DESIGN REVIEW COMMISSION STAFF REPORT

DATE: September 18, 2019

SUBJECT: **BAHIA RIVER VIEW**
FILE: P2017-023; DESIGN REVIEW
APN 143-151-06; BAHIA DRIVE, 400 FEET EAST OF CERRO CREST
DRIVE AND WEST OF TOPAZ DRIVE

Ridgeline

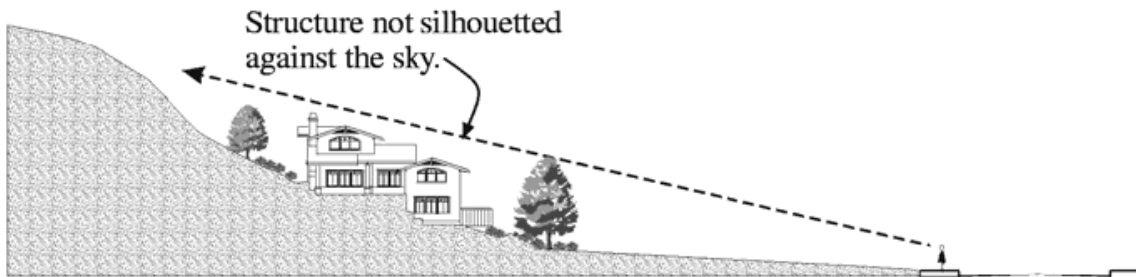
Novato Municipal Code Section [19.26.050.J \(Siting and Height Limitations\)](#), includes regulations regarding the siting of structures and height of structures adjacent to ridgelines. The project site includes a ridgeline, identified as the 150-foot contour line near the westerly edge of proposed Lot 1. A residence adjacent to the identified ridgeline shall have a minimum 25 feet of vertical separation from the ridgeline, meaning that the future residence located on Lot 1 cannot have a roof peak greater than 125 feet above sea level. Plan Set Sheet A0.1 includes a site section that depicts a “potential building” on Lot 1 that has a roof peak at the 125-foot elevation. Additionally, the structure on Lot 1 shall not be placed so that the structure is silhouetted against the sky when view from a public street. The siting of a future residence on the lower building pad of Lot 1, would ensure that the residence will not silhouette the sky against the backdrop of the ridgeline. The three images below and on the following page are excerpts from the Hillside Ordinance (Figure 3-11), which demonstrate the siting requirements for structures adjacent to ridgelines. The proposed lot configuration is consistent with the ridgeline siting and height limitation regulations.
